Flight Procedures Cover Page	Task Action: FLIGHT CHECK	Task Type: IAP	Estimated Chart Date: 12/02/2021	APWS Task ID: 93E64ACC05944CB880FFCD9510449F4F	APWS Project ID: 9E23E099A9A64C4C845EC3D452012776
Procedure: RNAV (GPS) RWY 25 AMDT 2		Enroute: NO	Specialist: Hill, Casey		Agreement Number:
Airport ID: KFMN		Airport City: FARMINGTON			State: NM
Facility ID:	Facility Type:	Flight Inspection Remark Type: Hold FC Slot

RNAV (GPS) RWY 25

FARMINGTON/ FOUR CORNERS RGNL (F'MN)

**DEPARTMENT OF TRANSPORTATION
FEDERAL AVIATION ADMINISTRATION
CATEGORICAL EXCLUSION DECLARATION**

OLD

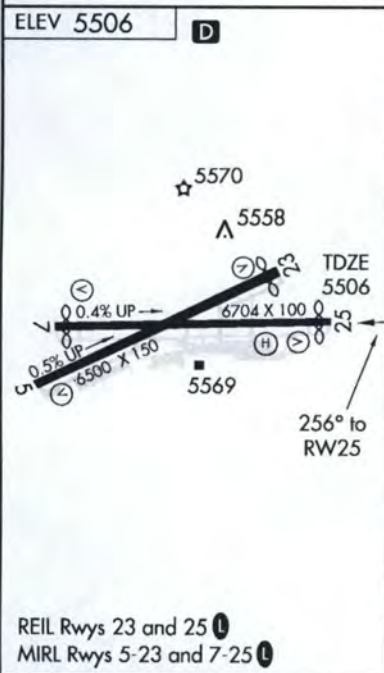
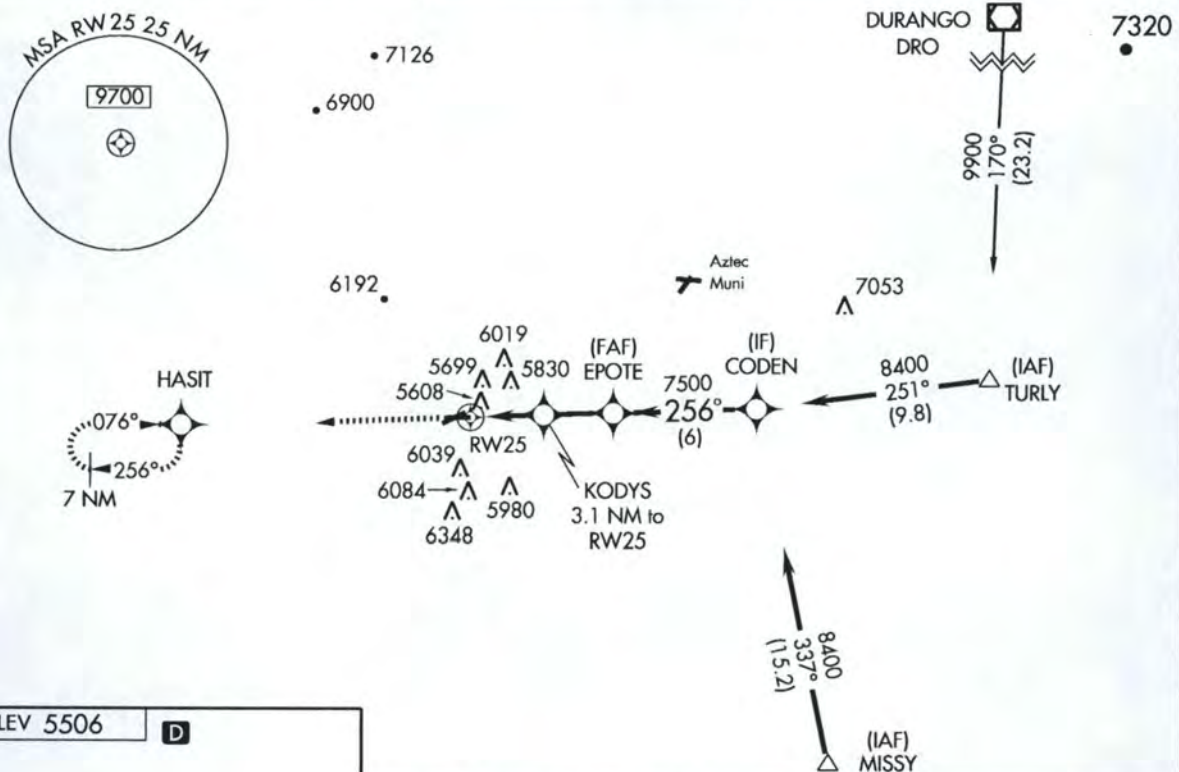
INCREASED FAF AND STEPDOWN TO MIRROR ILS

1. UPDATED CHART NOTE FROM CHART: AZTEC MUNI (Q19) TO CHART: AZTEC MUNI (N19).

2. UPDATED TERMINAL ROUTES FROM "EPOTE TO KODYS/3.64 NM TO RW25" TO "EPOTE TO KODYS/3.39 NM TO RW 25".

RNAV (GPS) RWY 25

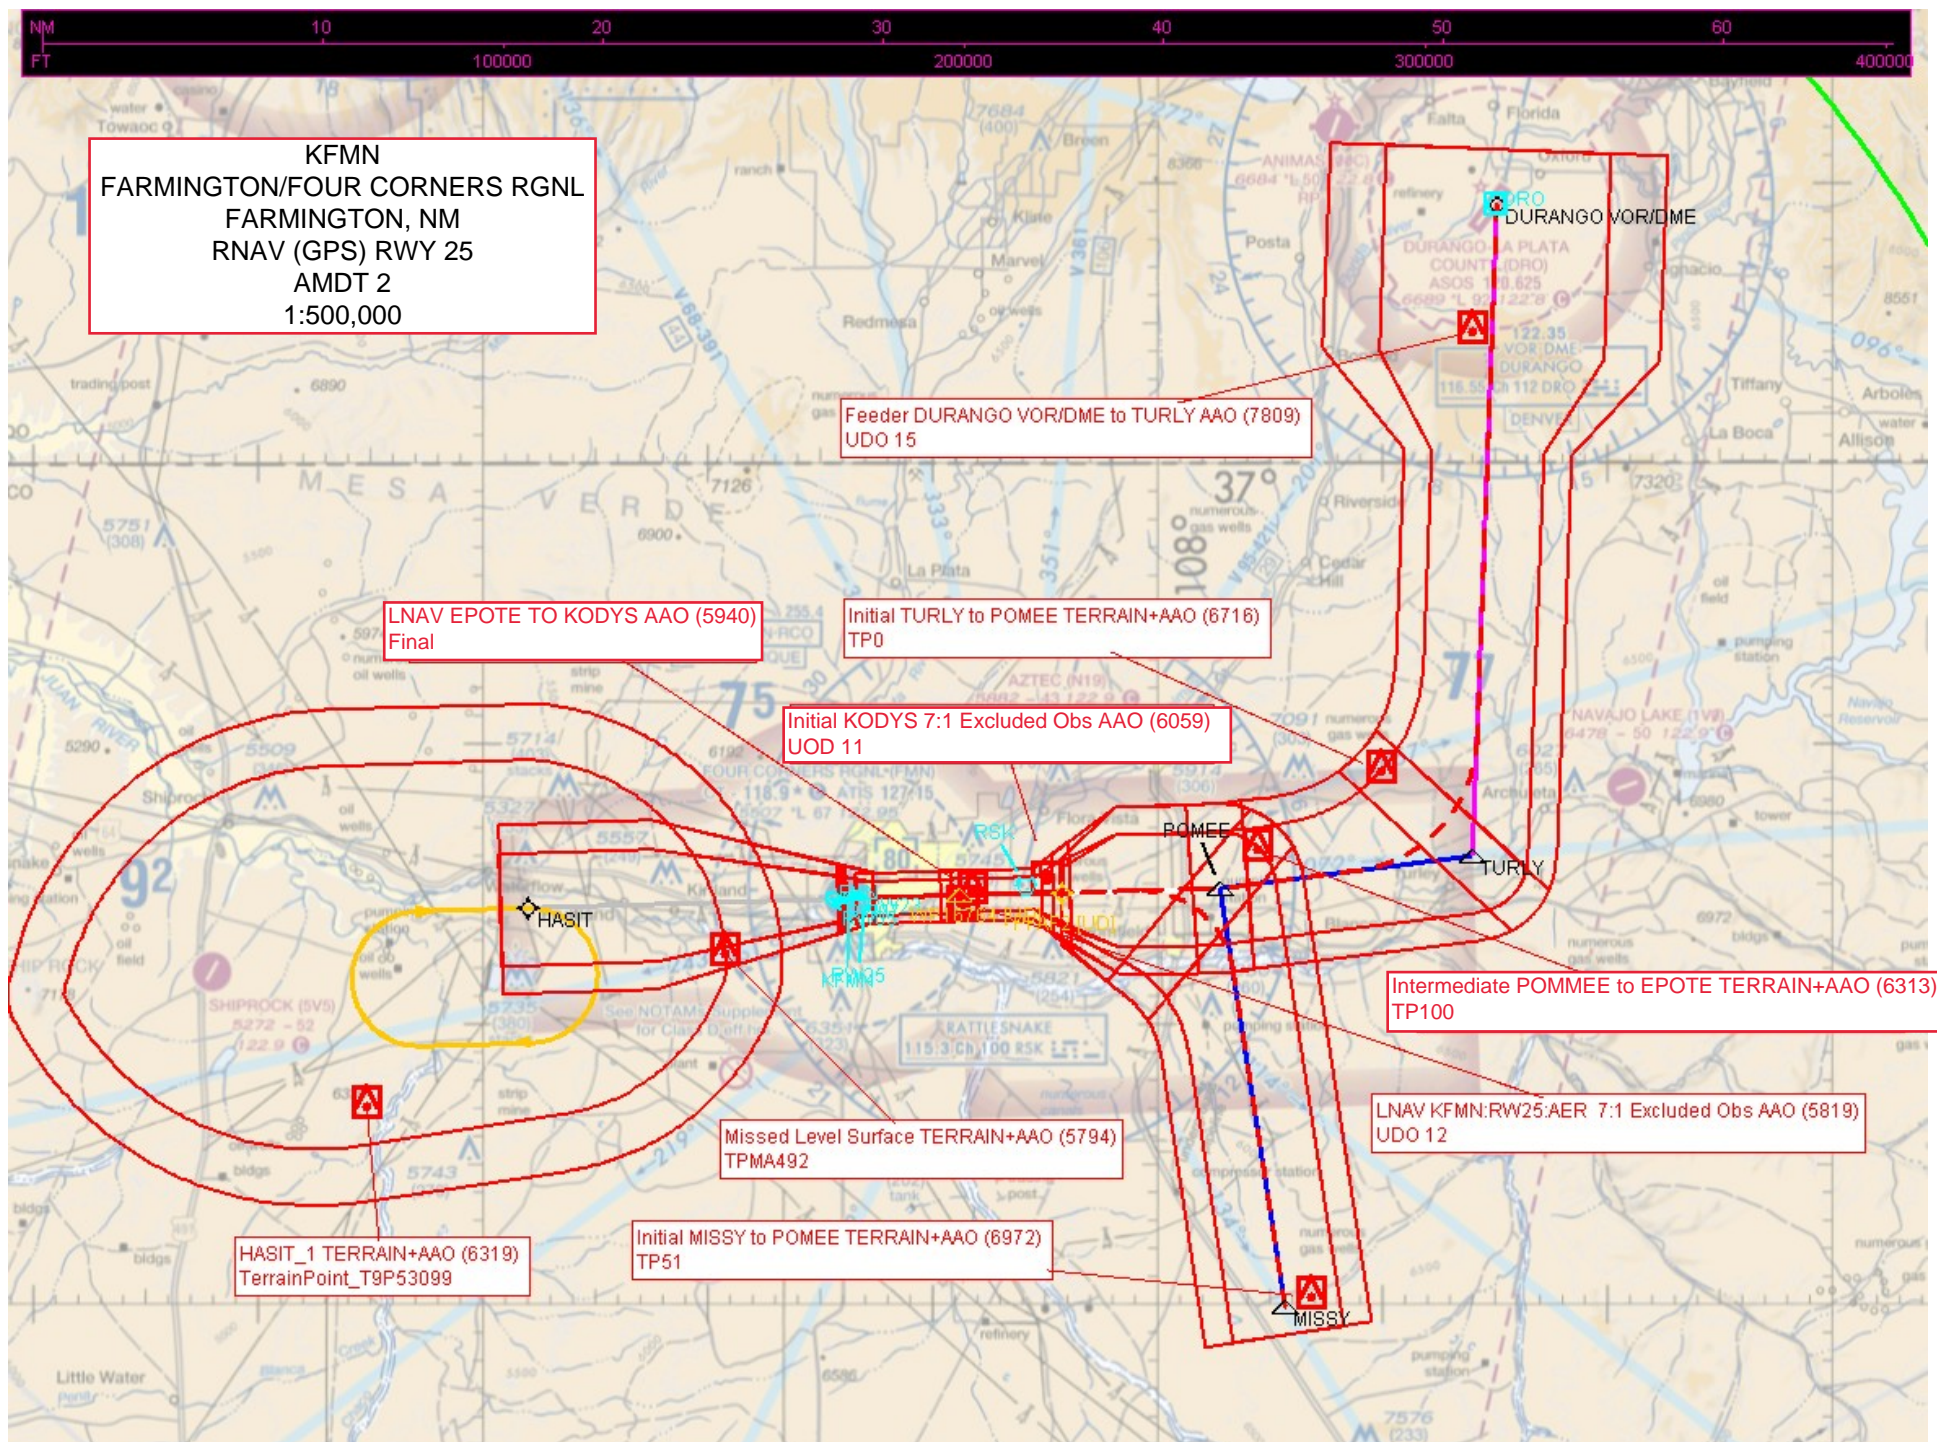
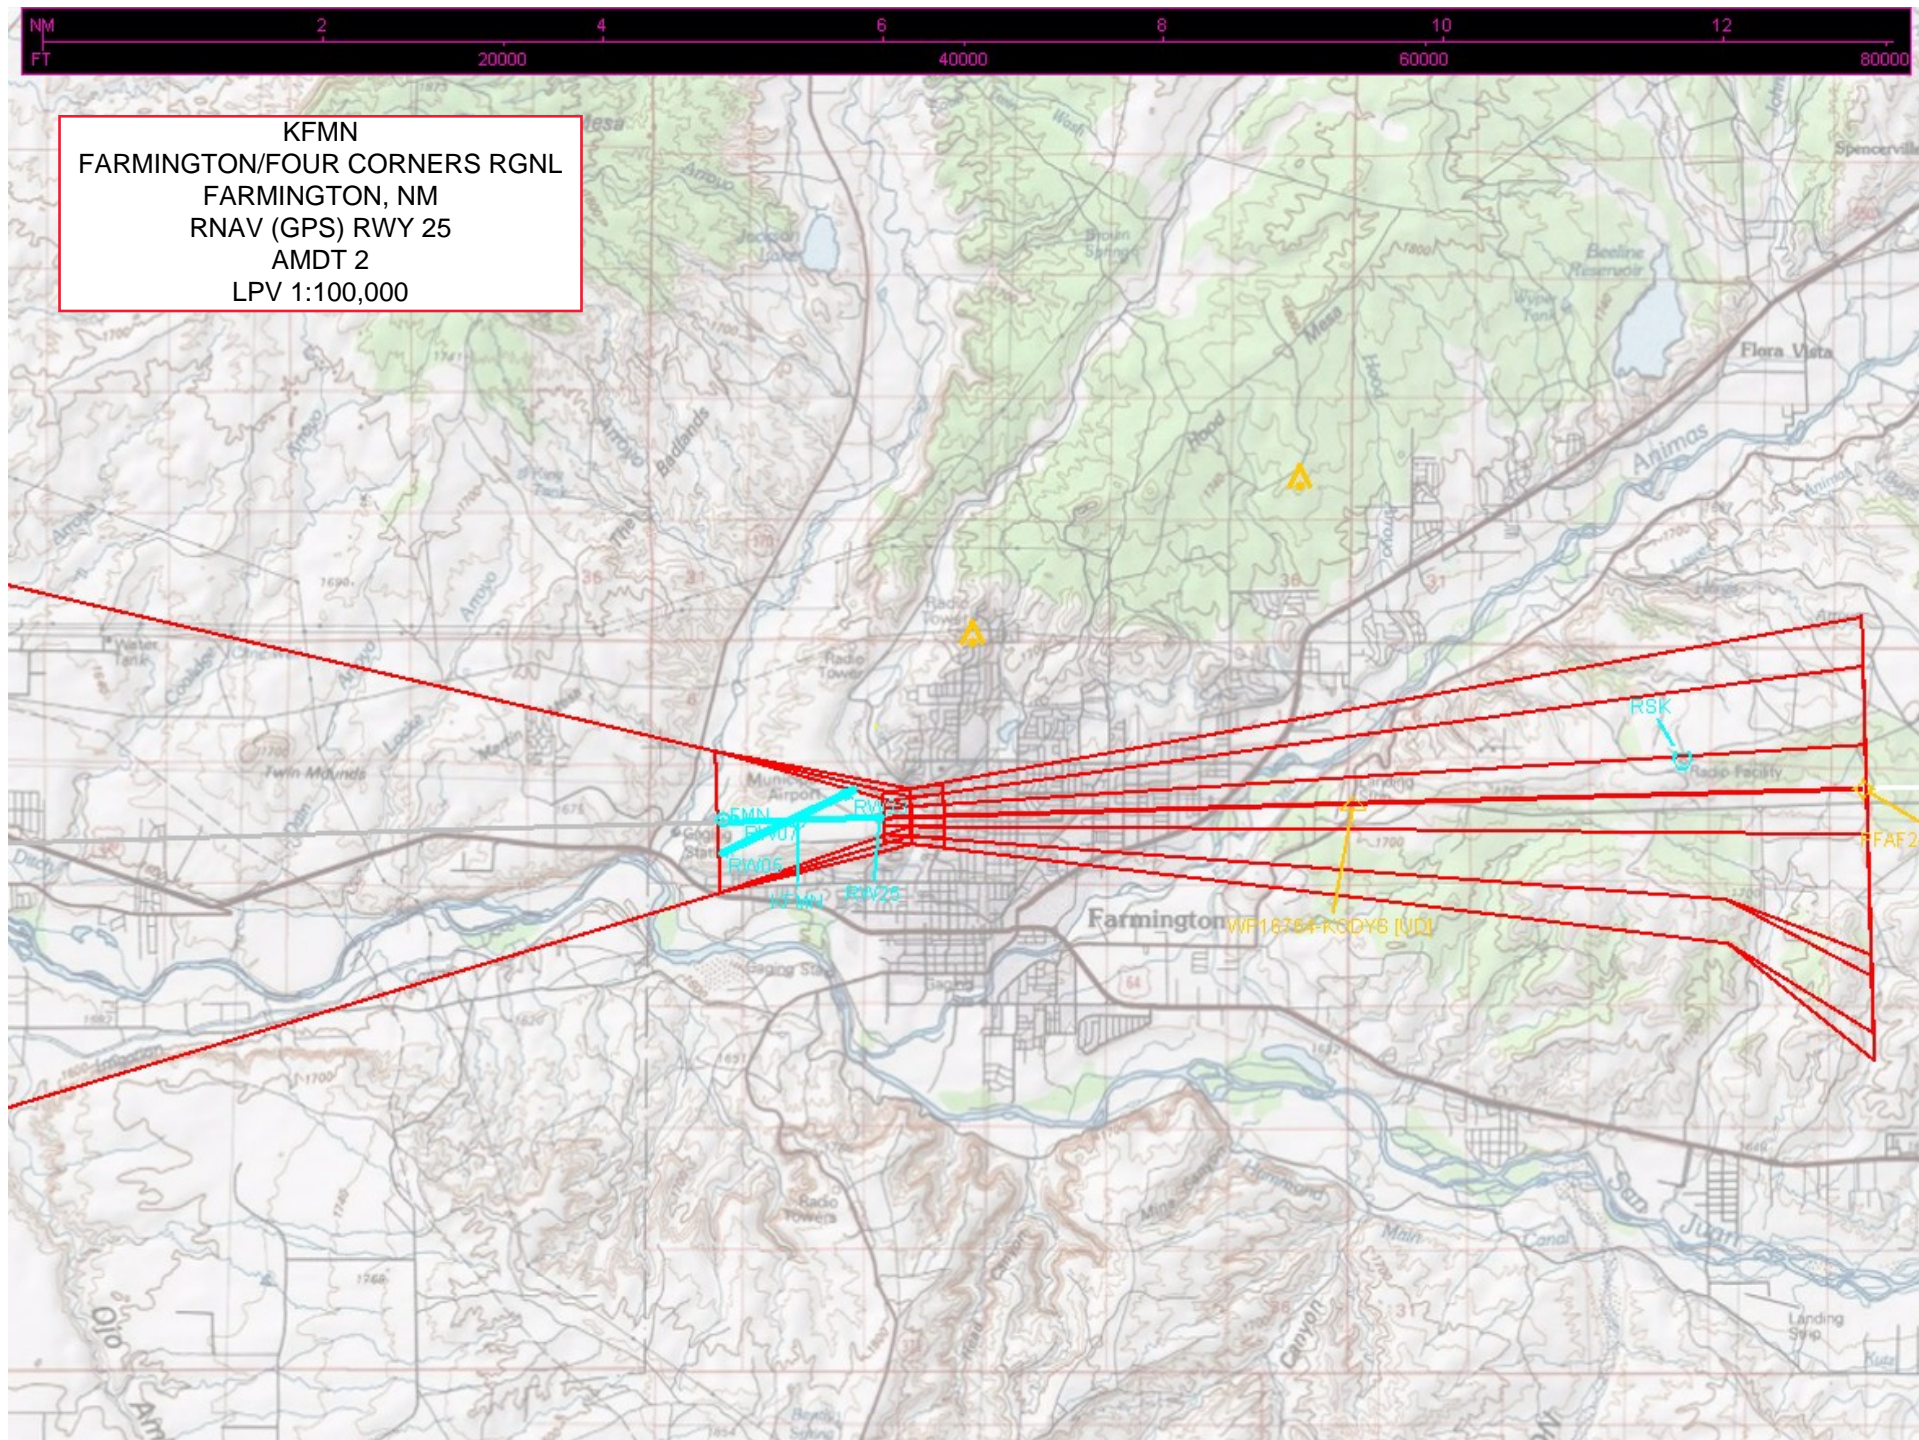
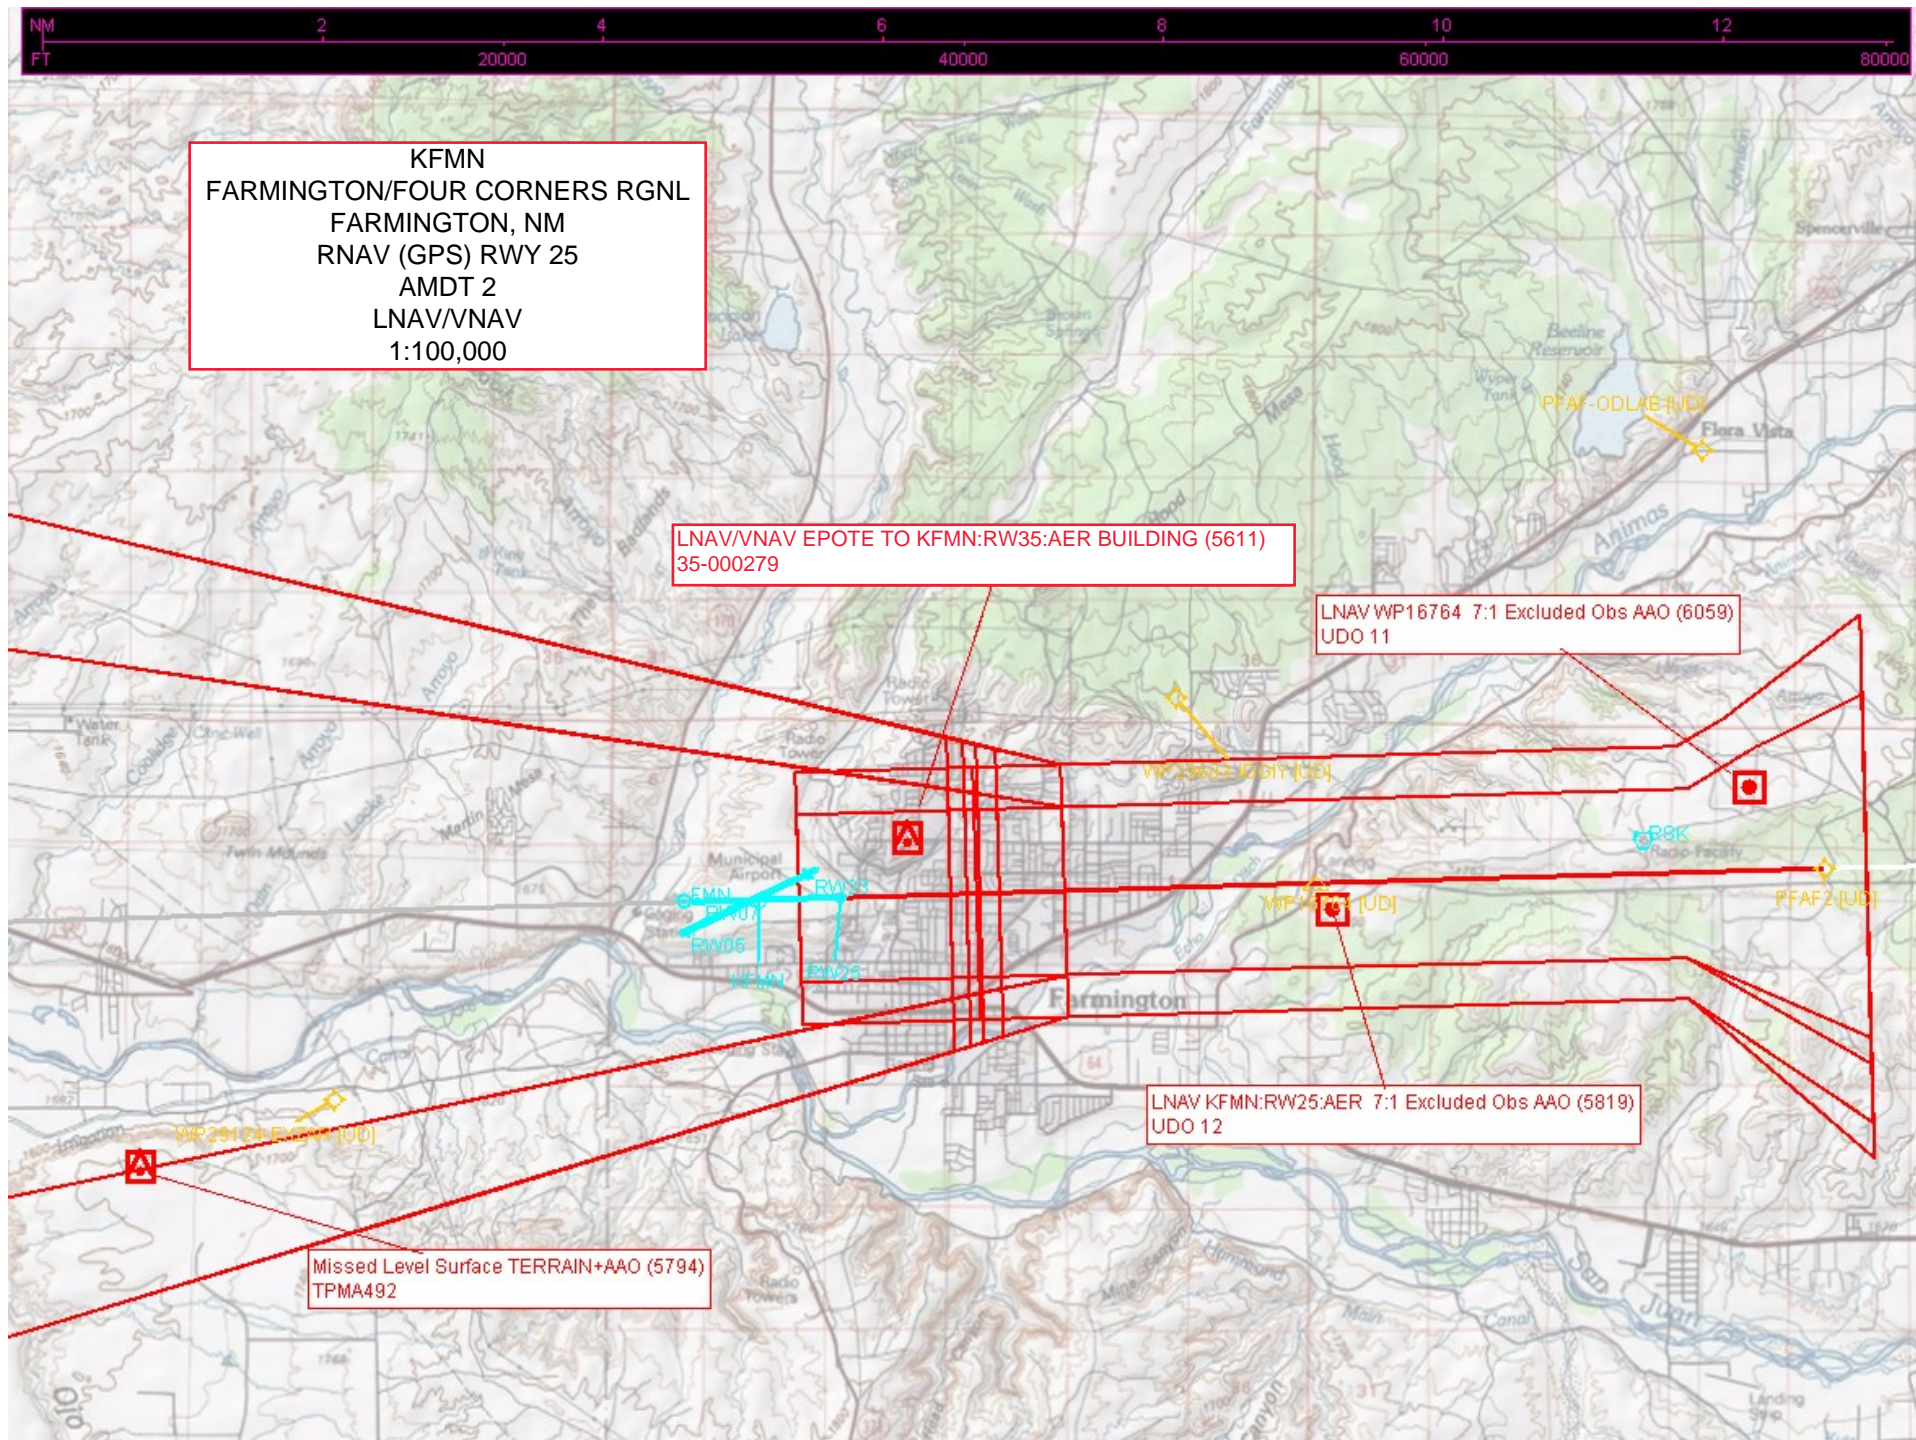
2. For RNAV (GPS) RWY 25: The proposed change deletes the existing Intermediate Fix (IF) CODEN and replaces it with a new IF POMEE, which will be located .69 Nautical Miles (NM) west of the current IF. Because the lateral change between the current and new IF is so small, the bearing to the Initial Approach Fix (IAF) TURLY will remain unchanged (251 degrees) as will the bearing to the secondary IAF MISSY (337 degrees). However, aircraft on both flight paths will track slightly differently (within one degree) from their historical flight tracks once the new IF POMEE is published.

3. For RNAV (GPS) RWY 25: There are currently two stepdown fixes on the final approach, but the proposed procedure will only use one stepdown fix. There will be no discernable change in where aircraft are flying.
